**BACK RIVER PROJECT**  
**Responses to Review of Water and**  
**Load Balance Report and Hydrodynamic and Water**  
**Quality Modelling of Goose**  
**Lake Report**

**21 November 2022**

## Responses to Review of 2021 Water and Load Balance Report and Hydrodynamic and Water Quality Modelling of Goose Lake Report Comments

**Figure B1: Predicted Timeseries Concentration of Water Quality Constituents in Goose Lake at the Edge of Mixing Zone for PN04 over the Construction, Operations, Closure and Post-closure Periods**

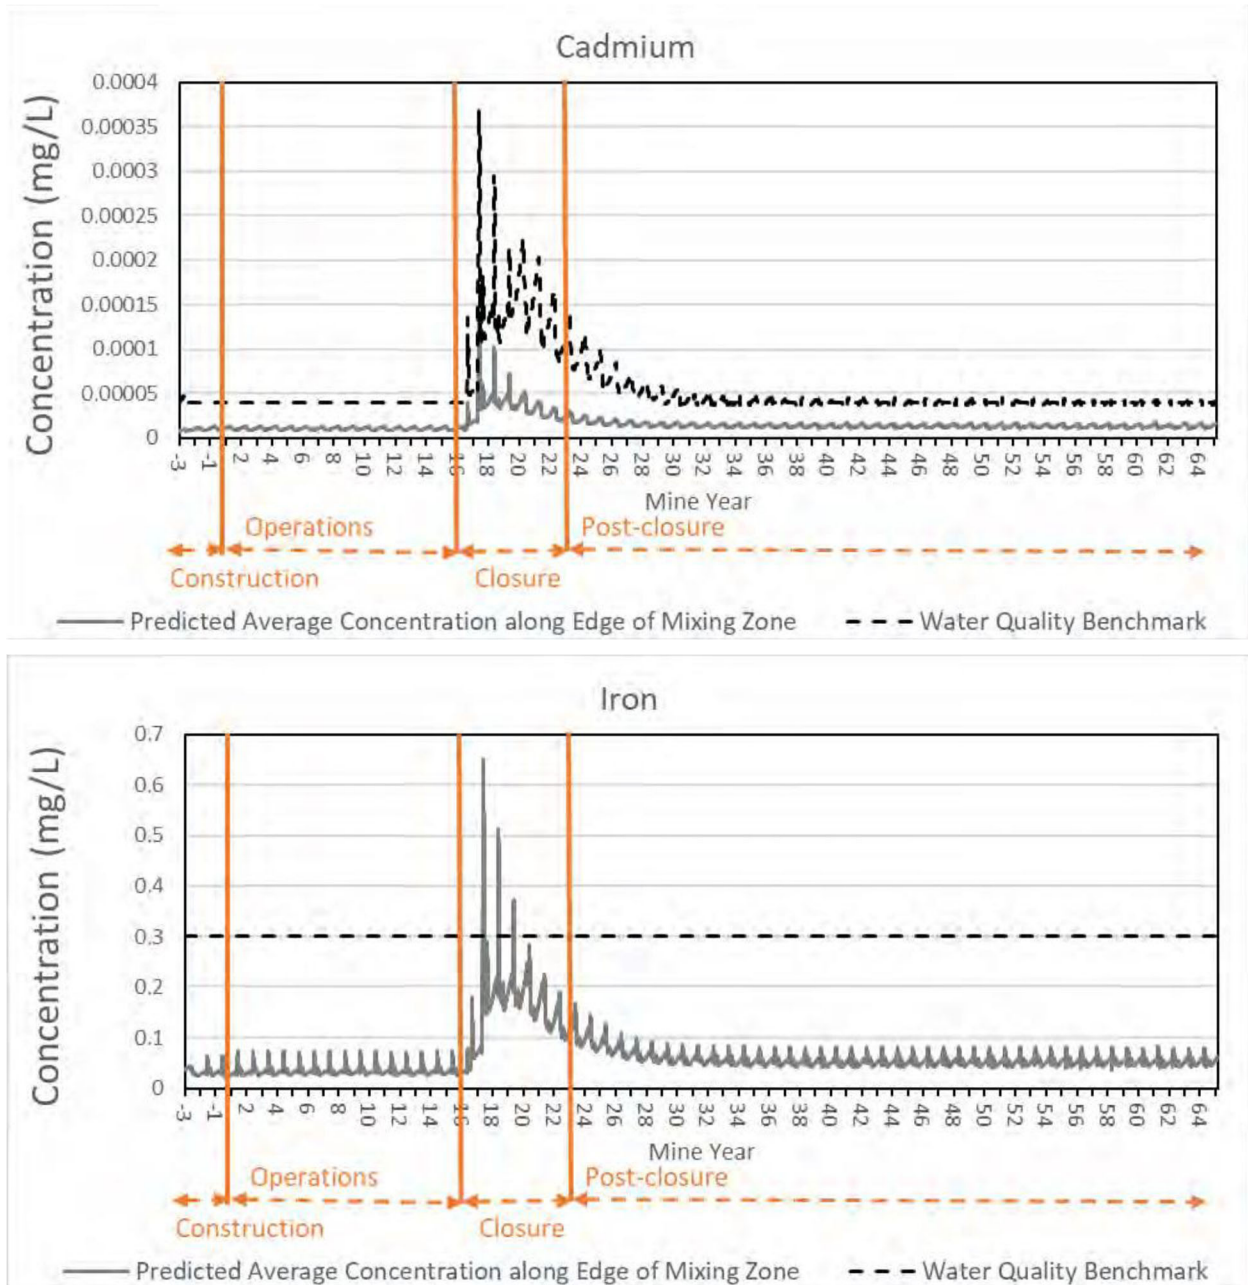
timeseries predicted constituent concentration figures from Appendix B illustrate the exceedance of parameter specific objectives.

**Figure C1: Predicted Timeseries Concentrations of Water Quality Constituents in Goose Lake at GLCB over the Construction, Operations, Closure and Post-closure Periods**

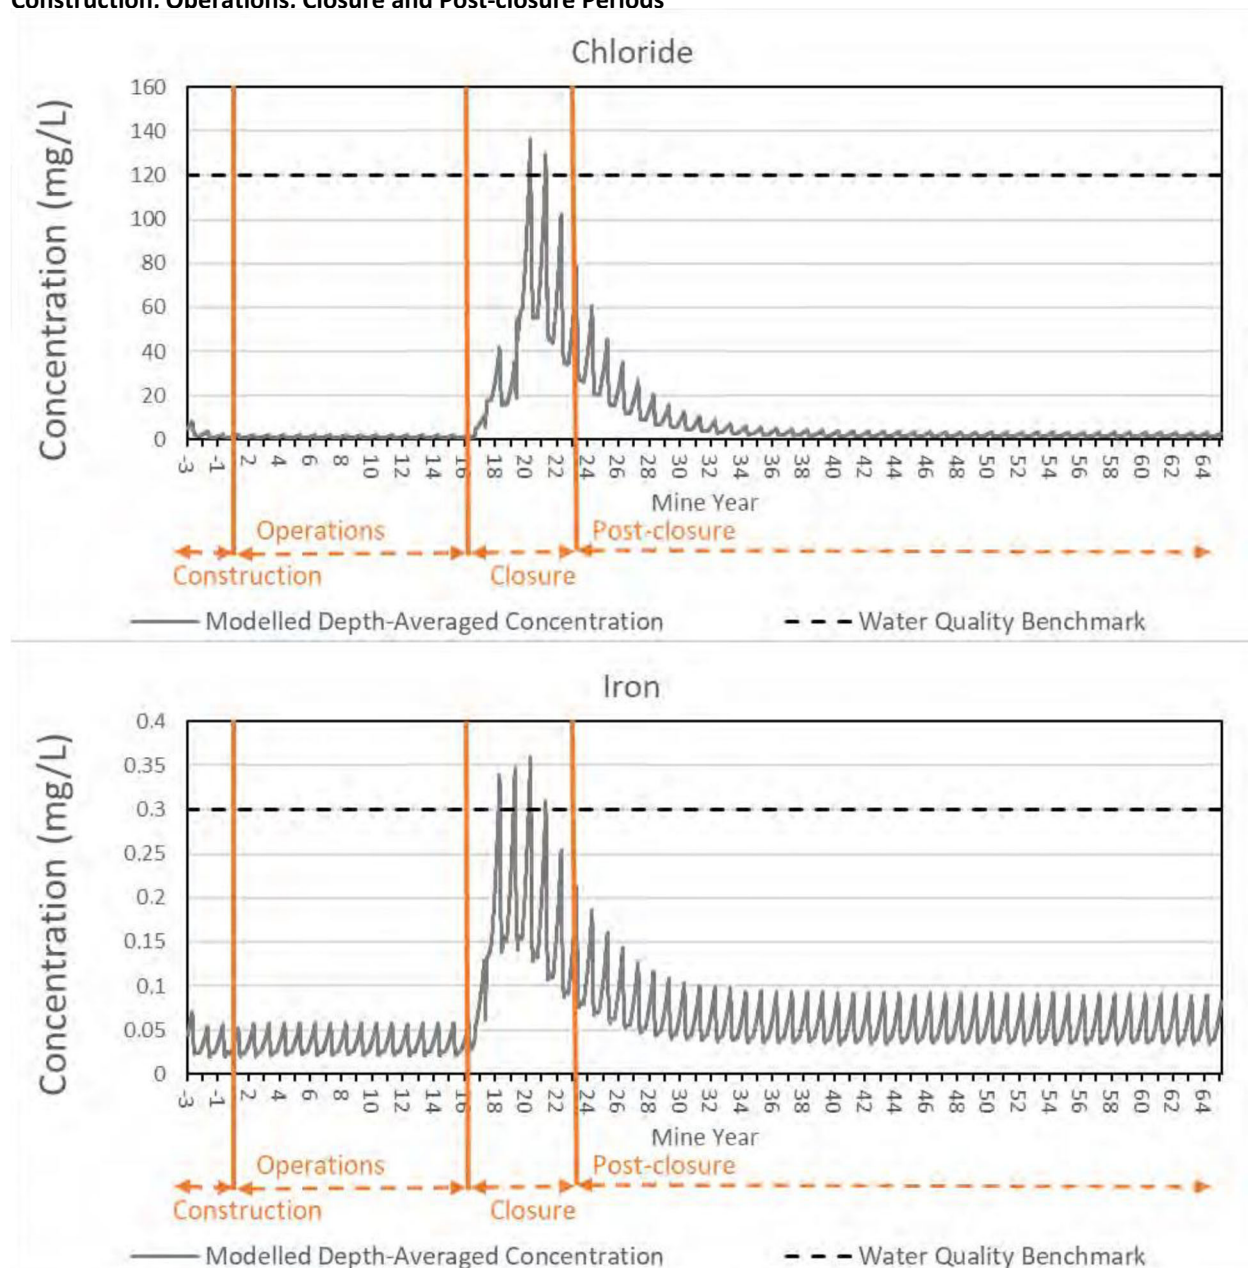
The predicted timeseries concentrations for nickel, chloride, iron and selenium at the central basin and tail of Goose Lake indicate multiyear exceedance of chronic guideline of the entire lake, indicating the potential for prolonged deleterious effects to aquatic life. It is recommended that Sabina either prove that the guidelines are overprotective for this particular site or provide mitigation efforts to reduce impacts. While exceedances are acceptable within the mixing zone, whole lake exceedances are not.

It is recommended that Sabina either demonstrate that the generic guidelines for nickel, chloride, iron and selenium are overprotective for this particular site (e.g., derive a site-specific water quality objective) or provide mitigation efforts to reduce potential impacts to aquatic life due to multiyear exceedances of chronic guidelines (e.g., provide water treatment when contact water is predicted to result in lake wide exceedances).

Sabina confirms the predicted concentrations of nickel in the central basin and tail of Goose Lake are below the water quality benchmark (Table 1 in the Hydrodynamic and Water Quality Modelling of Goose Lake Report), and as per response to KIA-NWB-2, acknowledges that the scale of plots in the Hydrodynamic and Water Quality Modelling

Sabina confirms that predicted concentrations of chloride, iron, and selenium remained below water quality benchmarks (Table 1 in the Hydrodynamic and Water Quality Modelling of Goose Lake Report) in the central basin of Goose Lake (see Figure C1 in report). Per response to KIA-NWB-2, the predicted infrequent (i.e., less than 5% of predictions), localized (i.e., in the tail of Goose Lake) and temporary (i.e., occurring 2 to 4 years in Closure) exceedances of chronic guidelines for chloride, iron and selenium are not expected to result in harmful effects to aquatic life in Goose Lake. Finally, per response KIA-NWB-2, predicted iron concentrations in the tail of Goose Lake are below the draft Federal Environmental Quality Guideline (FEQG) suggested to be used by ECCC (see IR response ECCC-01). Sabina has proposed mitigation to treat discharge to Goose Lake so that the resulting concentrations in Goose Lake are not expected to be harmful for aquatic life.

Figure CIRNAC-R-06-1: Model Mesh Applied in the EQC Report with Updated Color Scale

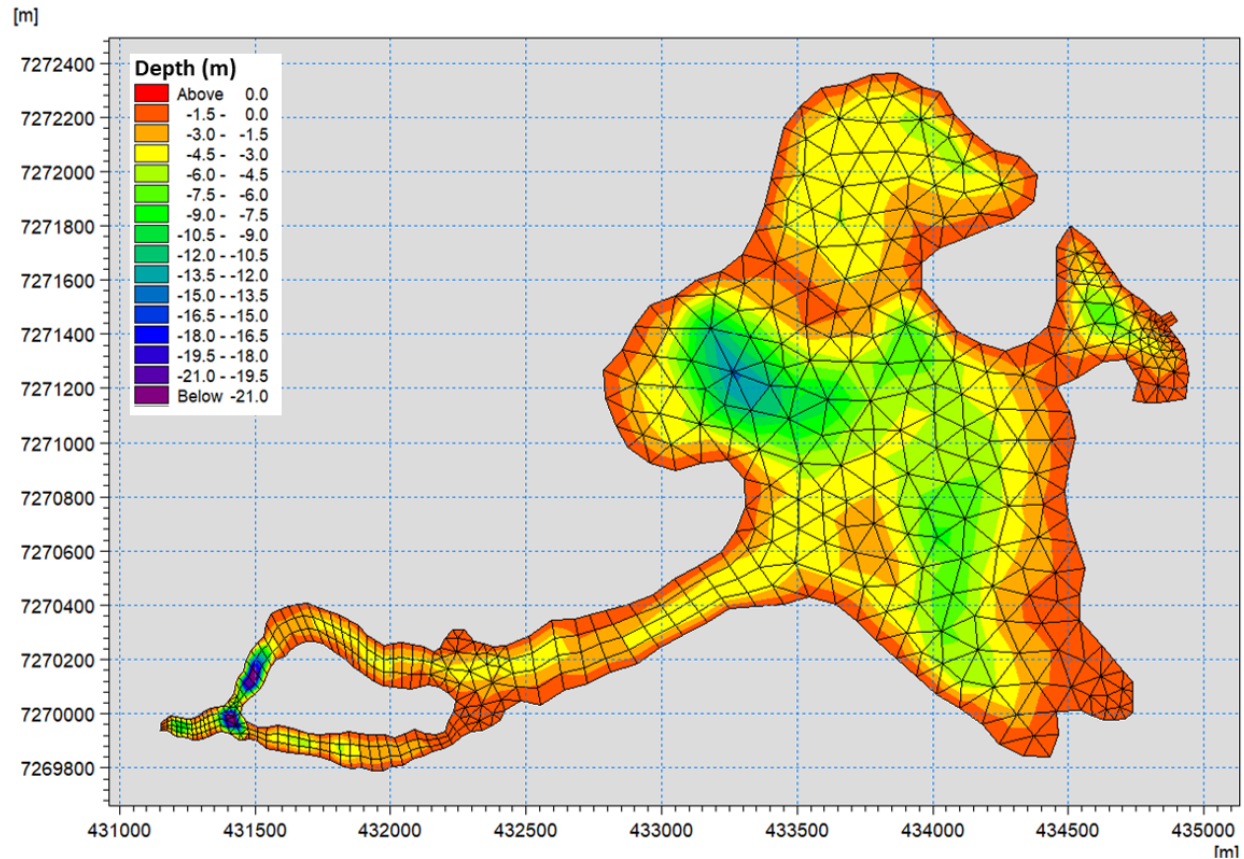
Figure 1 in Section 3.1 of the Hydrodynamic and Water Quality Modelling of Goose Lake Report presented the bathymetry and model mesh of Goose Lake.

CIRNAC notes that there is an apparent increase in areas of Goose Lake with depth greater than 14 meters when compared to data presented in Figure 1 of the 27 May 2021 Effluent Quality Criteria Report for Effluent Discharged from Tailings Facilities, Tailings Storage Facilities, or Reservoirs (Version 1). However, no discussion is provided on this apparent change in Goose Lake bathymetry.

Sabina confirms that the hydrodynamic model mesh presented in the Hydrodynamic and Water Quality Modelling of Goose Lake Report (Golder 2022; Figure 1) is correct. There are two reasons for the observed difference between the figure presented in the Golder (2022) and the Effluent Quality Criteria (EQC) Report (Golder 2021):

1. Sabina clarifies that, unfortunately, the legend included on Figure 1 of Golder (2021) report is incorrect and does not belong to the presented color scale. The model mesh applied in the Golder (2021) is presented in Figure CIRNAC-R-06-1 with an updated color scale.
2. As part of the 2022 hydrodynamic model update (Golder 2022), minor edits were made to the model mesh. The mesh was re-evaluated against the bathymetric data to identify the areas that the mesh resolution could be improved. Thus, the mesh cells around certain localized areas in the lake were deepened to better match the bathymetric data.

Sabina further confirms that the analysis and findings of the Effluent Quality Criteria (EQC) Report (Golder 2021) remain valid.
